S E R V I C E N O T E

HP MODEL 8690B SWEEP OSCILLATOR

Serial Prefixes 1124A and Below

MODIFICATIONS TO IMPROVE RELIABILITY

Figure 3. Modified A4 Helix Amplifier Board Assembly

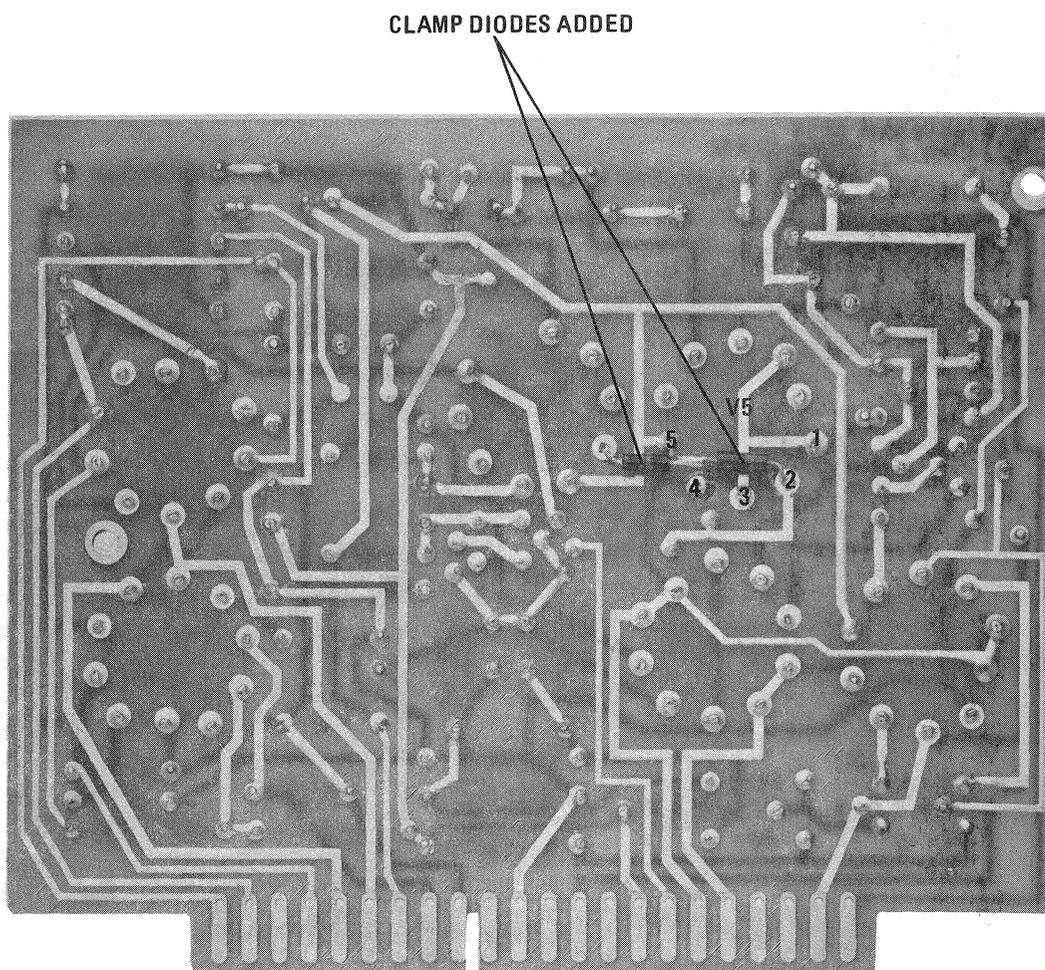
Part No. 1901-0033) from the grid of V5 (Pin 2) to ground. The anodes of the two diodes should be soldered together. The cathode of the Zener diode connects to the grid of V5 Pin 2 and the cathode of the silicon diode connects to ground. See Figure 3.

Insure that the anodes of the diodes do not contact pins 4 and 5 of V5.

Figure 4. Component Identification, A8 Assembly

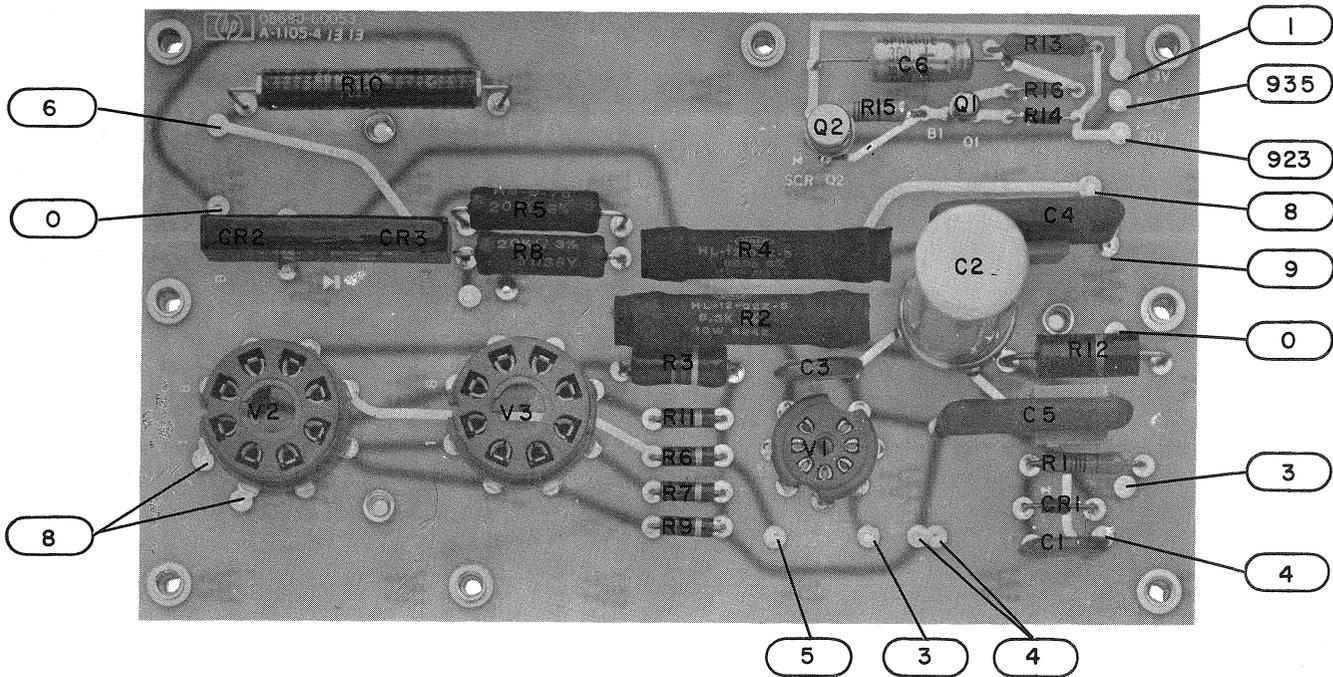
4. The A8 Helix Supply Board should be HP Part No. 08690-60053. Using the component identification photo (Figure 4) locate and remove C6, R13, and R16. Replace C6 with a 140 μ f capacitor HP Part No. 0180-2268. Replace R13 with a 562 K ohm resistor HP Part No. 0857-0868. Replace R16 with 909 ohm resistor HP Part NO. 0757-0422.

Figure 1. Modified A11 Amplitude Modulator Board Assembly

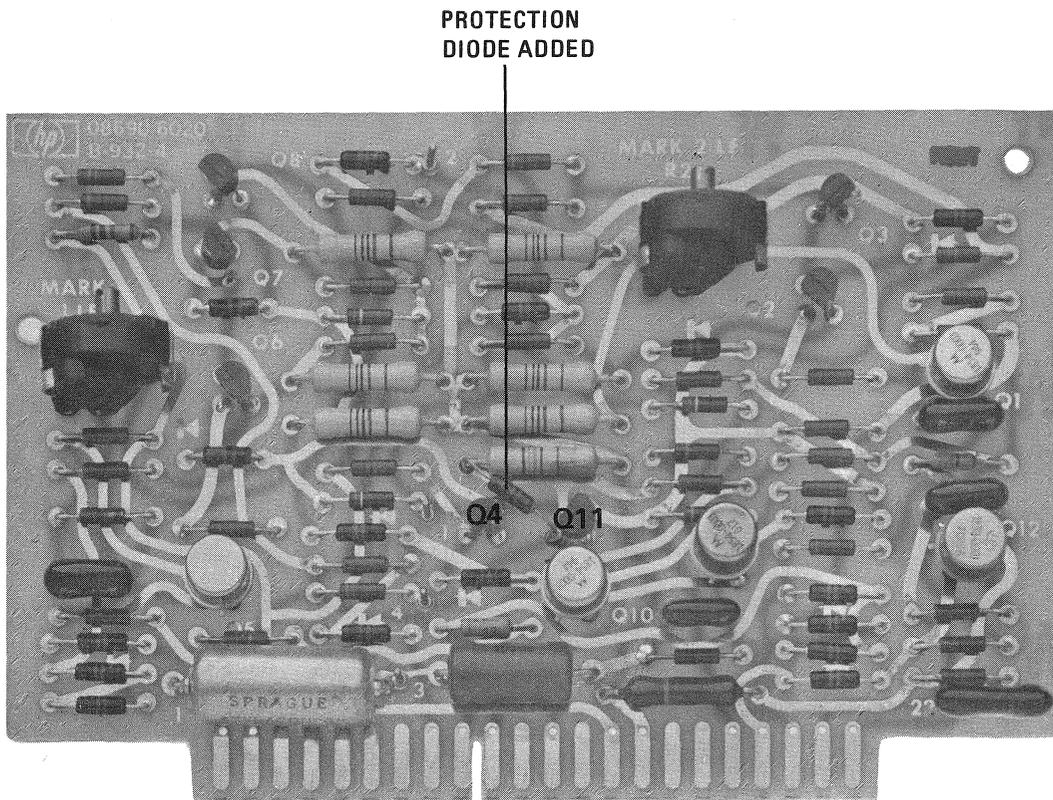
1. Turn 8690B line switch to Off position. Remove AC power cord from rear of instrument.
2. Remove top and bottom cover from 8690B.
3. Remove A11 Amplitude Modulator Board assembly from 8690B.
4. Remove and discard Q2, 3, 4, 6, 7, 8, and 11 and replace with silicon transistor (HP Part Number 1853-0020).
5. Install a diode (HP Part No. 1901-0033) from the base to emitter of Q11. Connect the diode anode to the base and the cathode to the emitter. See Figure 1.

Figure 2. Modified A3 Reciprocal Amplifier Board Assembly

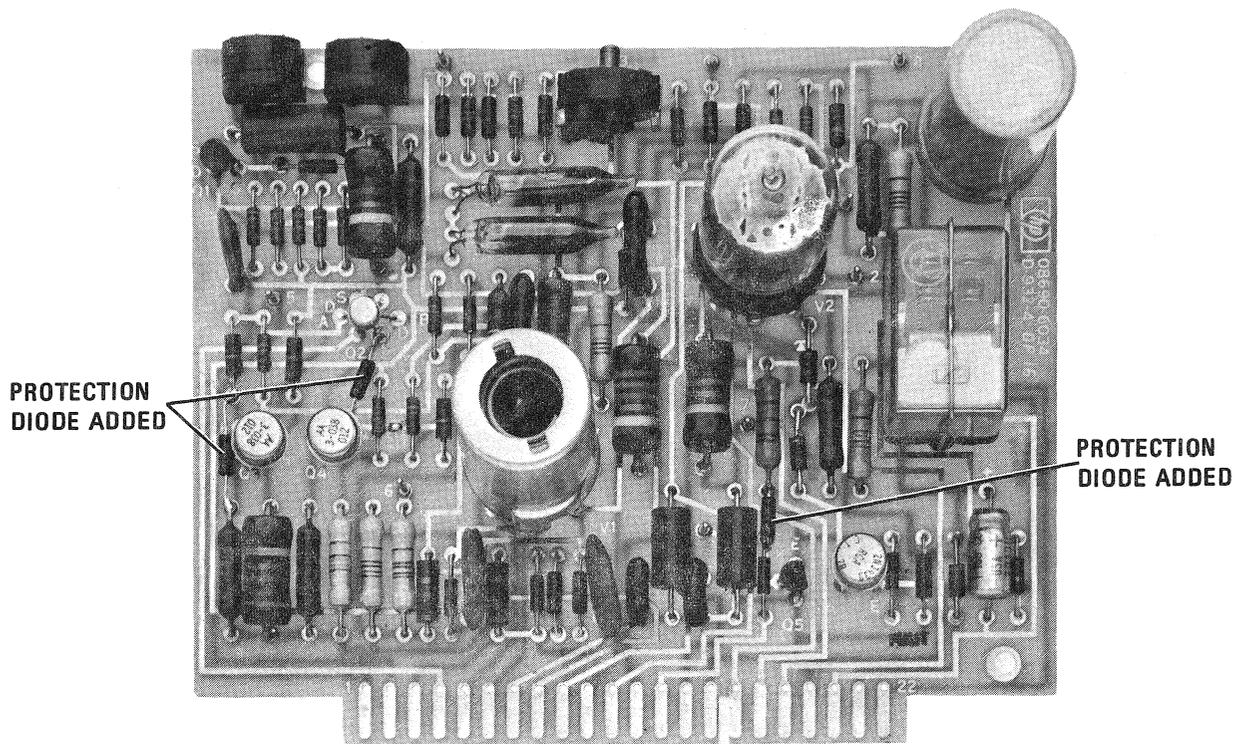
9. Replace the A10 board assembly back in the 8690B.
10. Remove the A3 Reciprocal Amplifier board assembly from the 8690B.
11. Install three protection diodes (HP Part No. 1901-0033) to Q3, Q4, and Q5. The diodes should be connected from the base to the emitter of the transistors with the anode connected to the base of the transistor and the cathode connected to the emitter. See Figure 2. Remove and discard Q6; and replace with Silicon Transistor (HP Part No. 1854-0079).

Figure 5. Component Identification, A4 Assembly

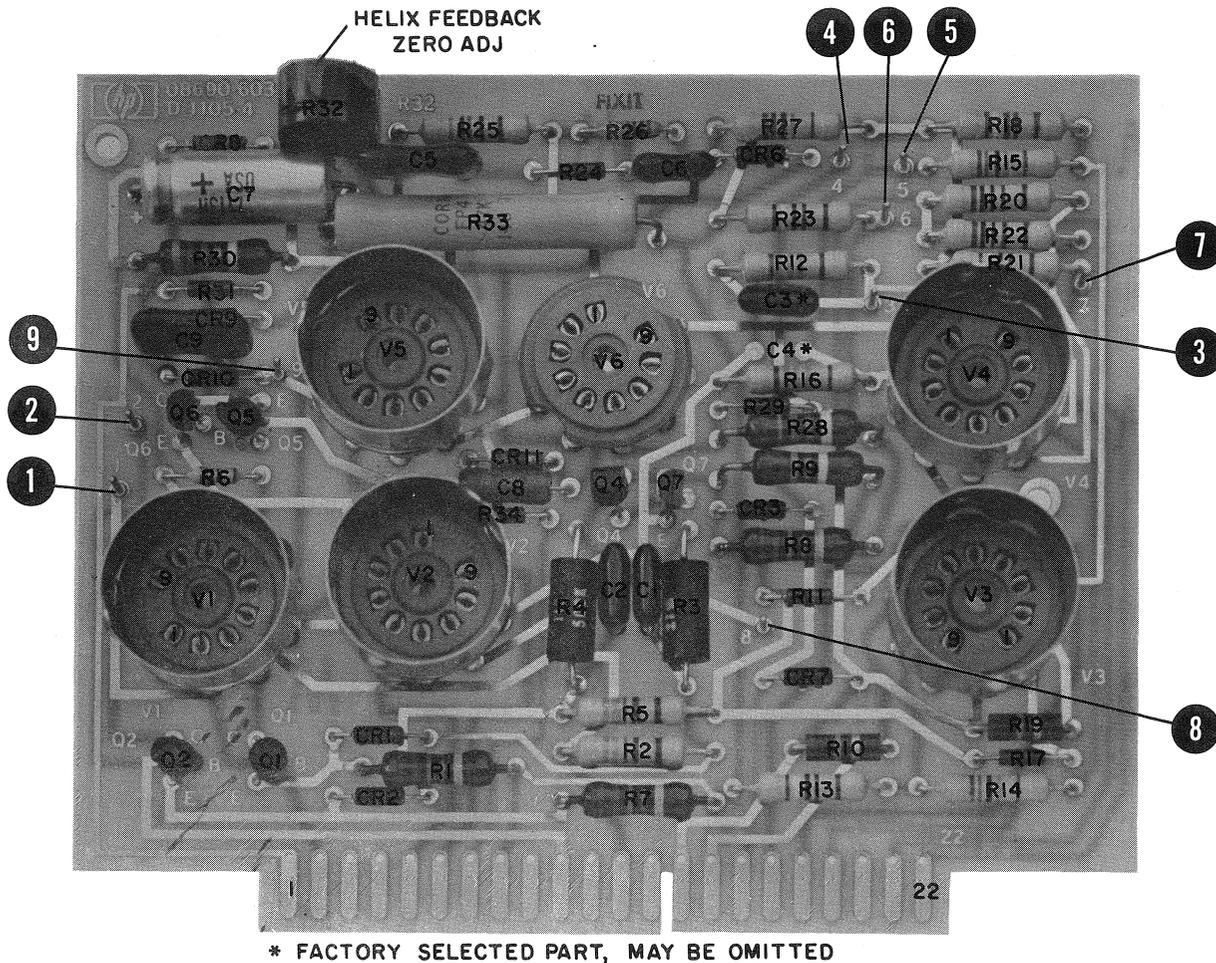
8. Replace the A5 and A6 board assemblies in the 8690B. Replace the two screws that secure the A6 board to the deck.
9. Remove the A4 Helix Amplifier Board from the 8690B. Using the Component Identification Photo (see Figure 5) locate CR11. Unsolder the anode end of CR11. Solder the cathode of a silicon diode HP Part No. 1901-0033 in the spot where CR11 was removed. Solder the anode of CR11 to the anode of the added diode.

4. Replace the A5 and A6 board assemblies in the 8690B. Replace the two screws that secure the A6 board to the deck.
5. Remove the A4 Helix Amplifier Board from the 8690B. Using the Component Identification Guide (see Figure 5) locate CR11. Unsolder the anode end of CR11. Solder the cathode of a silicon diode HP Part No. 1901-0033 in the spot where CR11 was removed. Solder the anode of CR11 to the anode of the added diode.
6. Replace the A4 Board in the 8690B.
7. Remove the A10 Sweep Generator Board assembly from the 8690B.
